## QUESTIONS AND ANSWERS #2

### RFQ 19H08021Q0067

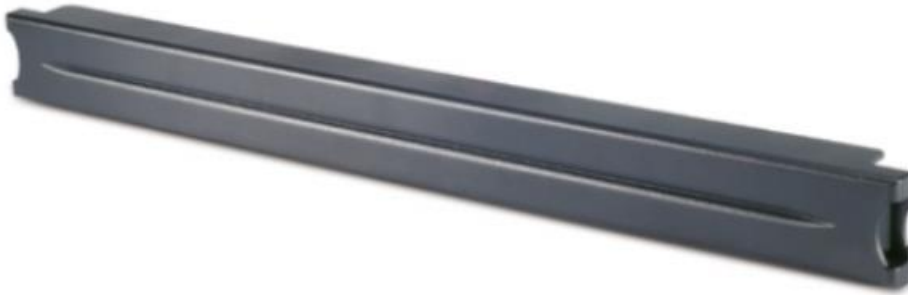
5. Please indicate if top cabinets cable management tray should be included. See photo

*A: No, the HNP will recycle some of the currently on hand at Casa Matta Data Center*

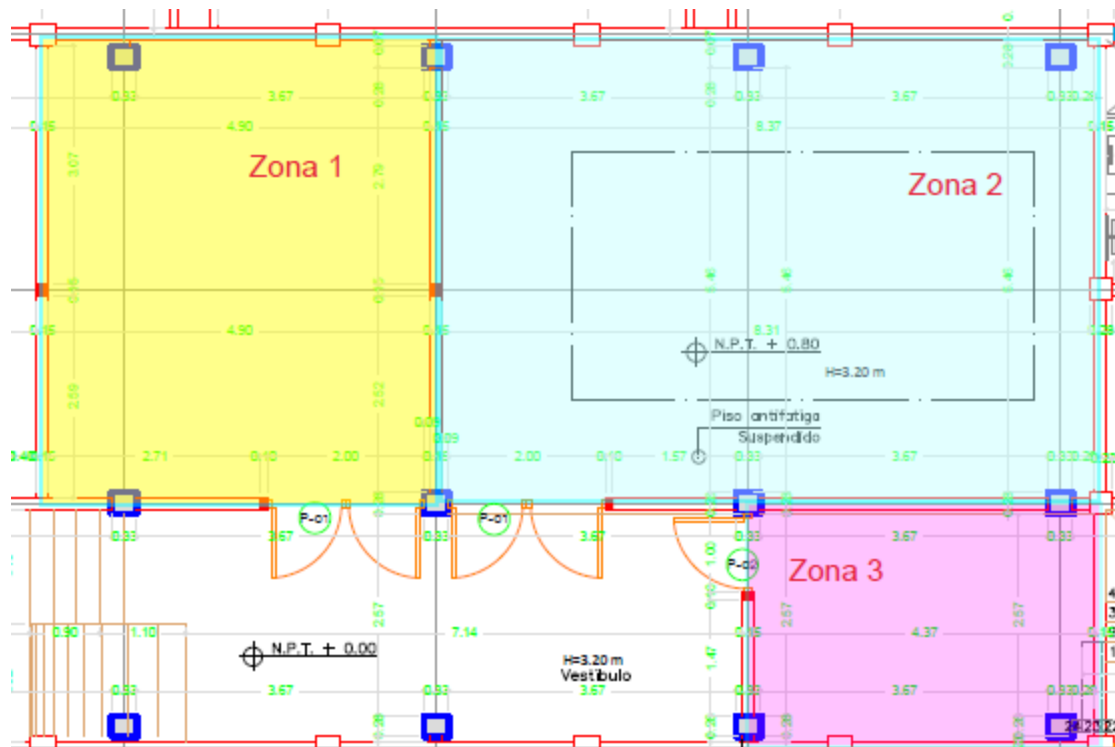
12. We have to cover an area of about 93 square meters

a. I want to be sure if these 93 square meters are these 3 zones?

*A: Yes, the three ones*
